ADDENDUM NO. 3

**South Fountains Restoration
Missouri State Capitol Building
Jefferson City, Missouri
PROJECT NO.: 02204-01**

JUNE 3, 2025

SOUTH FOUNTAINS -
WEST FOUNTAIN
(ARTS) - FOUNTAIN
ELEVATIONS

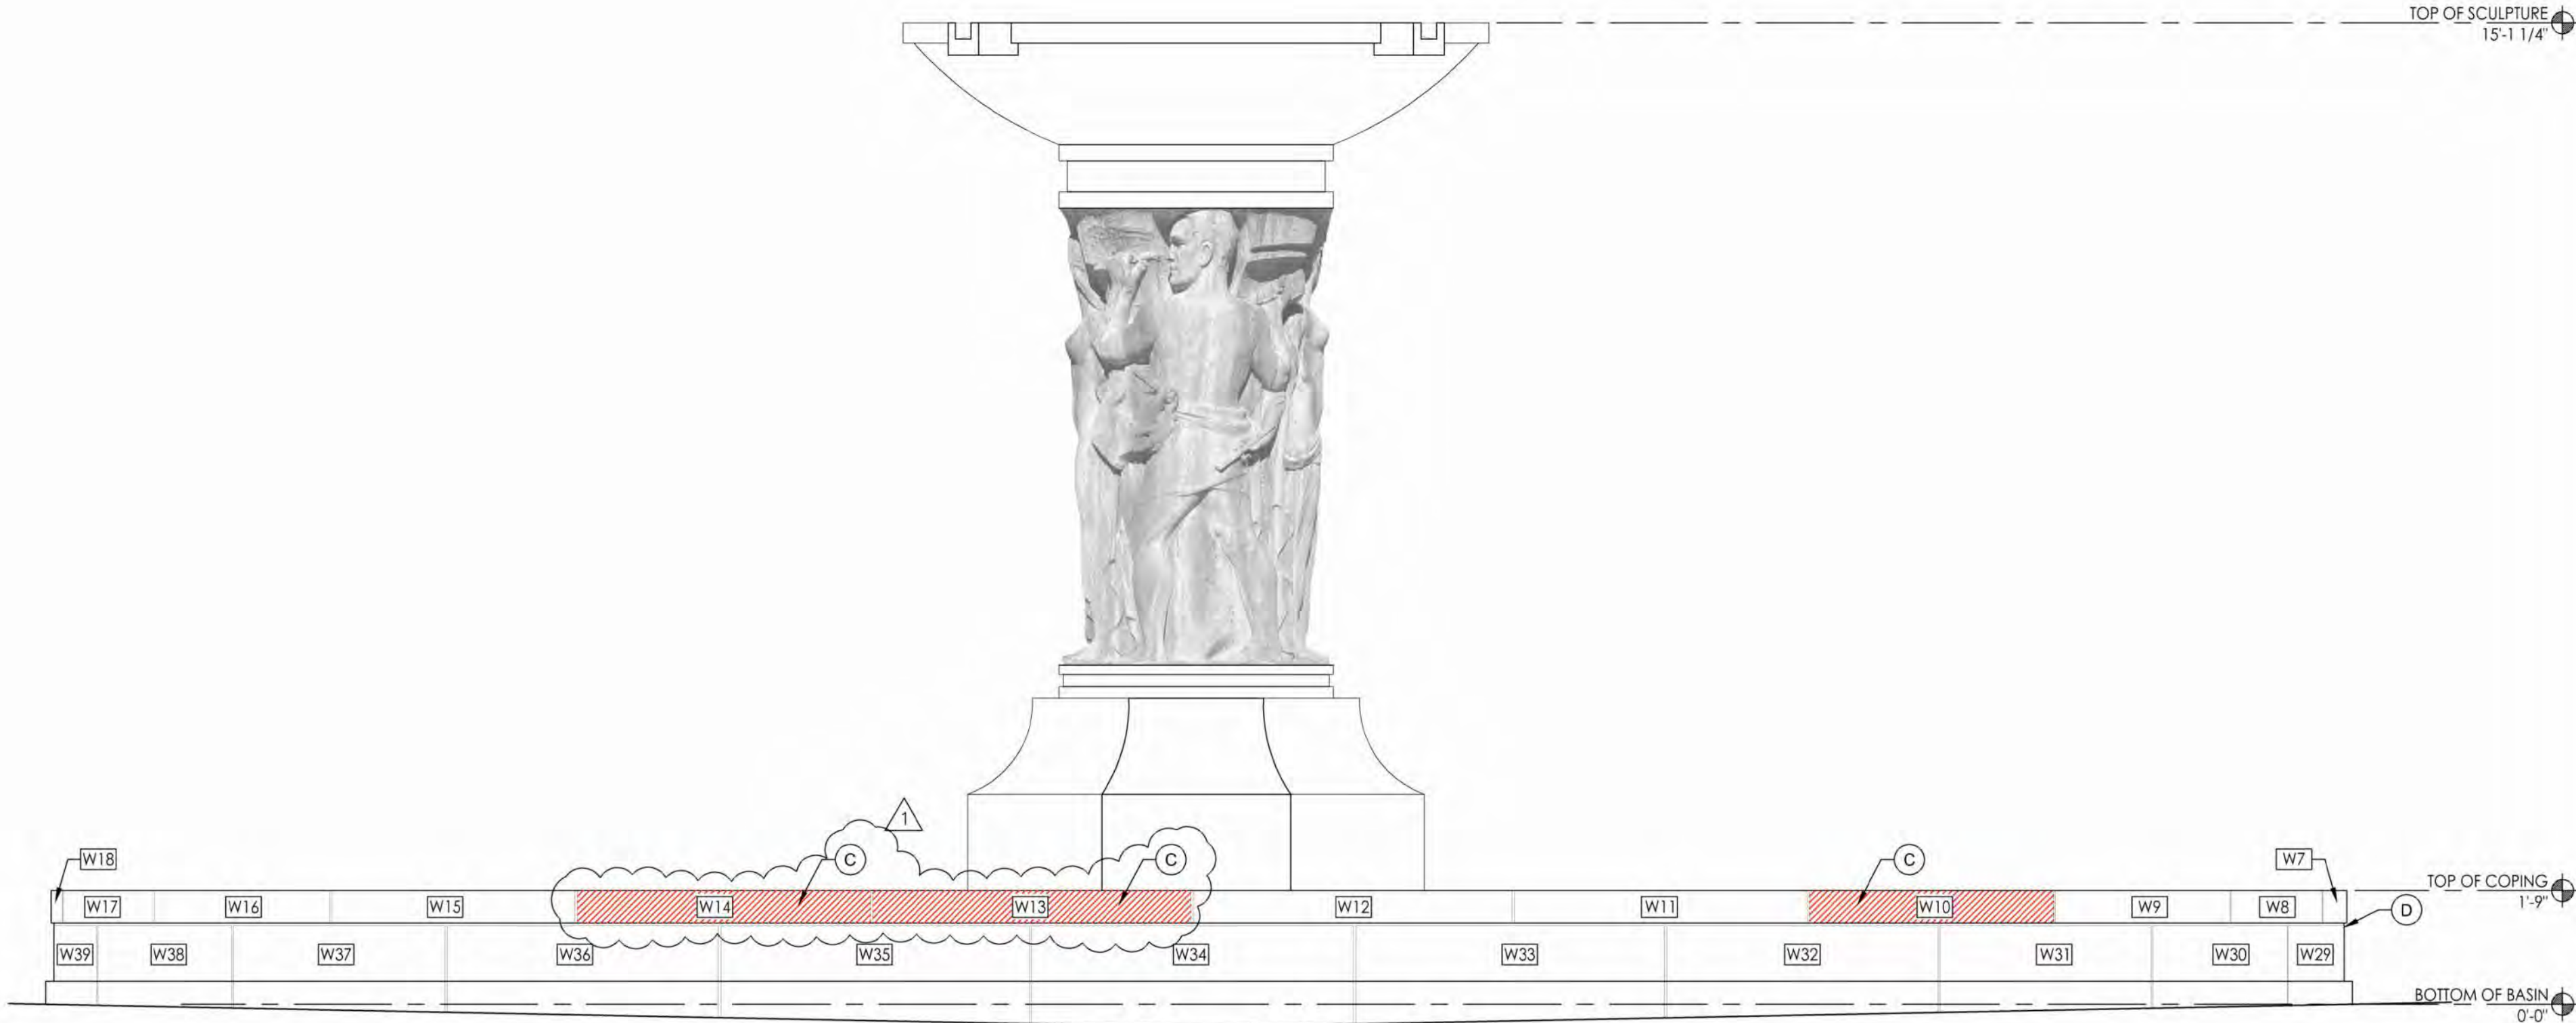
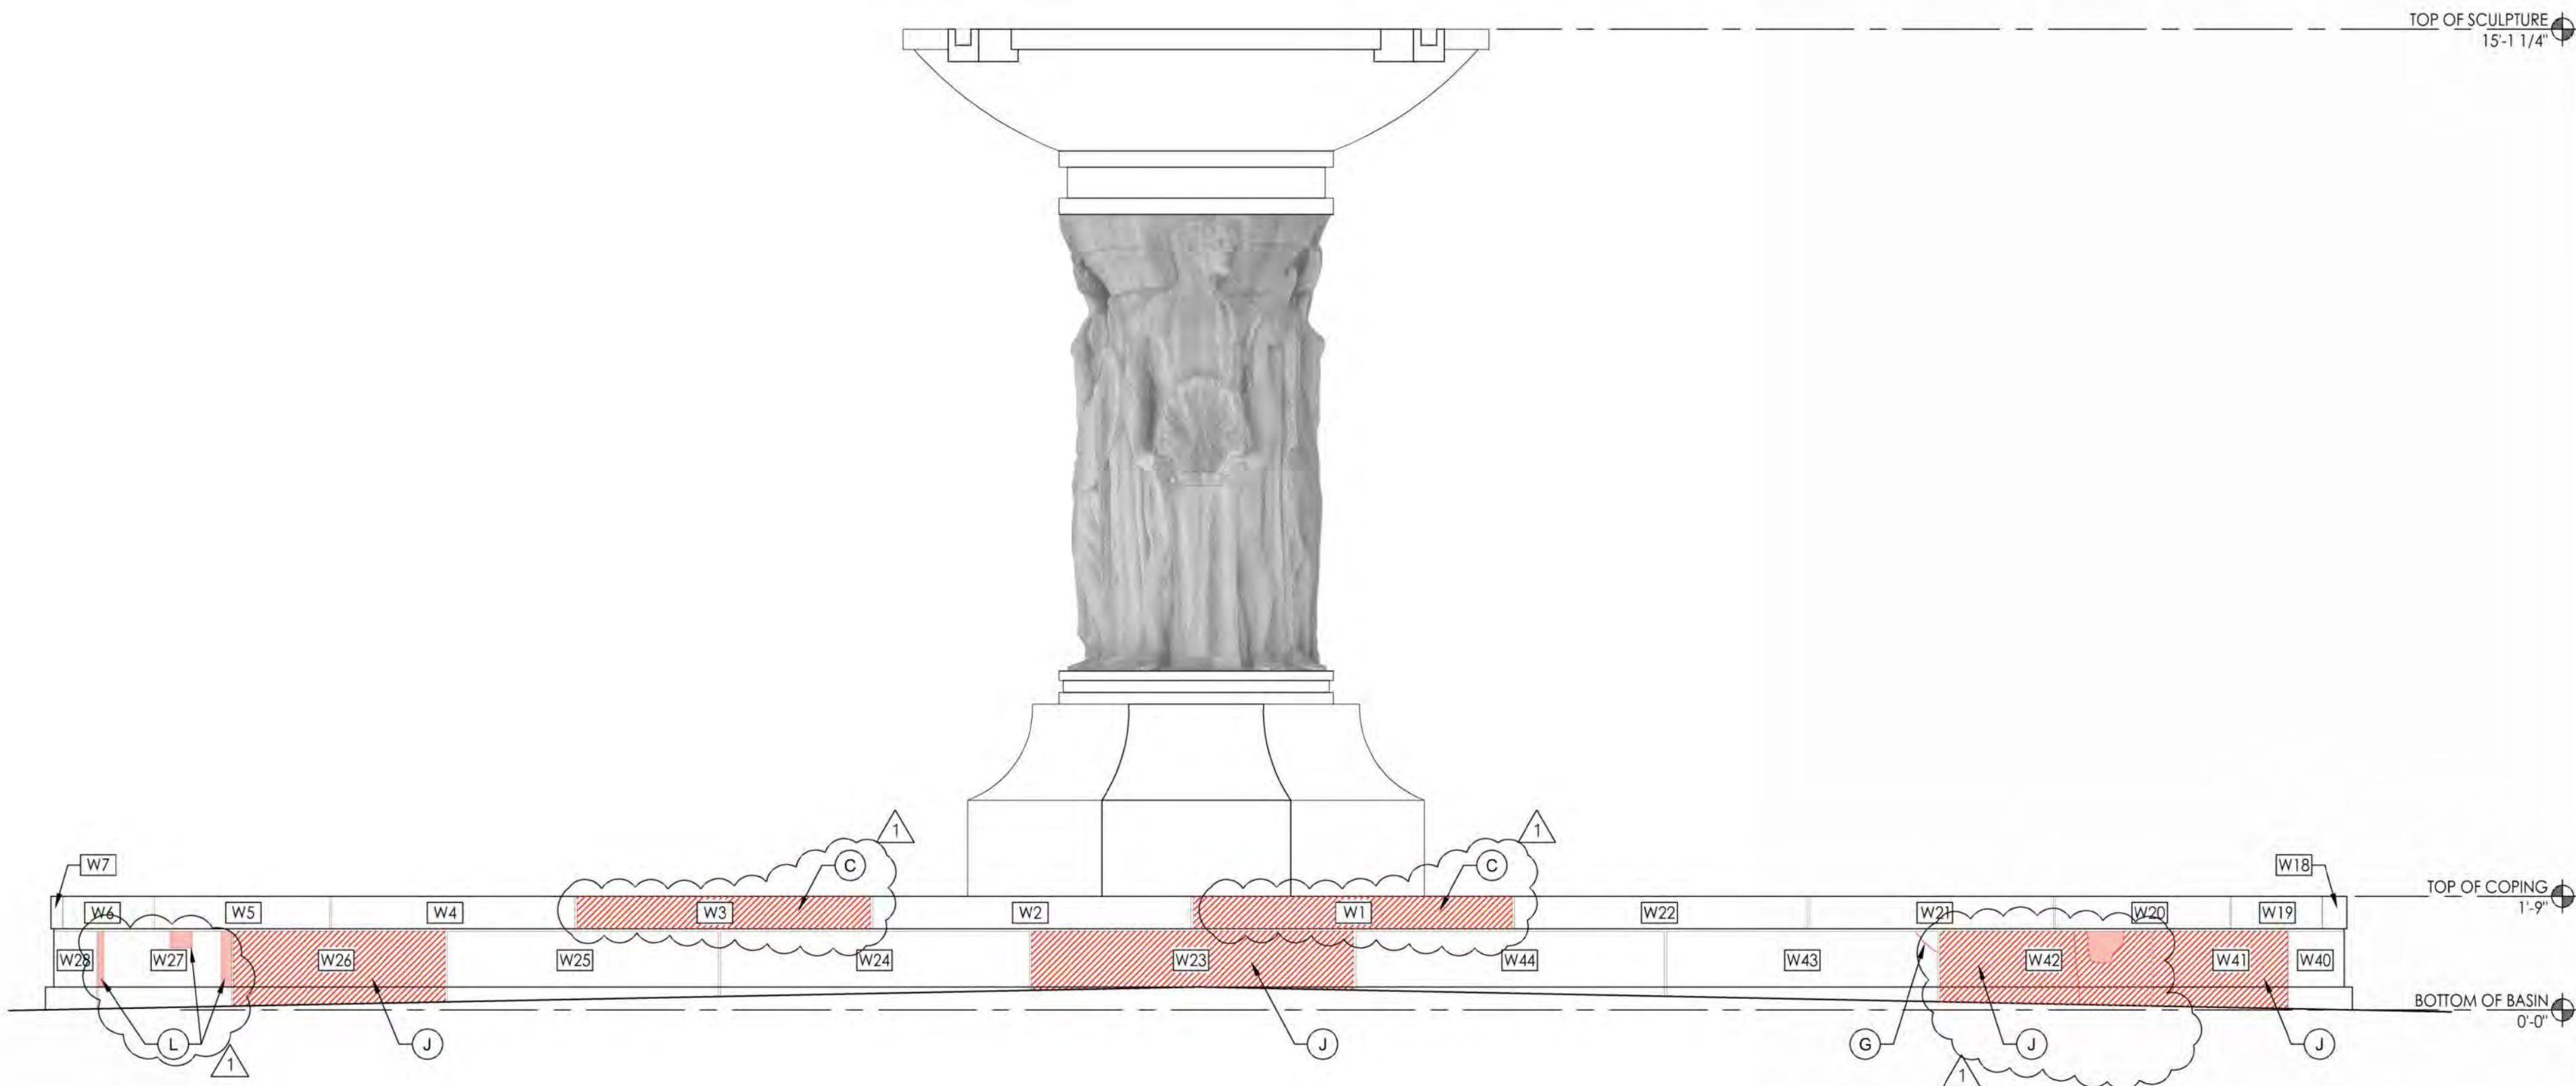
5. Sheet A200

- a. ADD General Note:
Stone units indicated for replacement shall be salvaged and reused in stone repair work where remainder of slab is in good condition and can be set using same bedding plane configuration.
- b. ADD South Fountains Keynotes as follows:
 - K. remove det'd stone area. install dutchman repair (approx 6"X12") using adjacent historic salvaged stone cap.
 - L. SPEC 040120 – Remove (3) damaged full depth portions of limestone vertical panel. Install full depth limestone dutchman patch at each location. Use removed and salvaged portion of historic stone for patches.
- c. Detail 1 – ADD fountain limestone coping and wall slab repairs and replacements
See W1, W3, W27, W41, and W42
- d. Detail 2 – ADD fountain limestone coping slab replacements
See W13, and W14

- STONE UNITS INDICATED FOR REPLACEMENT SHALL BE SALVAGED AND REUSED IN STONE REPAIR WORK WHERE REMAINDER OF SLAB IS IN GOOD CONDITION AND CAN BE SET USING SAME BEDDING PLANE CONFIGURATION.

- (K) REMOVE DETD STONE AREA. INSTALL DUTCHMAN REPAIR (APPROX 6'x12') USING ADJACENT HISTORIC SALVAGED STONE CAP.
- (L) SPEC 040120 - REMOVE (3) DAMAGED FULL DEPTH PORTIONS OF LIMESTONE VERTICAL PANEL. INSTALL FULL DEPTH LIMESTONE DUTCHMAN PATCH AT EACH LOCATION. USE REMOVED AND SALVAGED PORTION OF HISTORIC STONE FOR PATCHES.
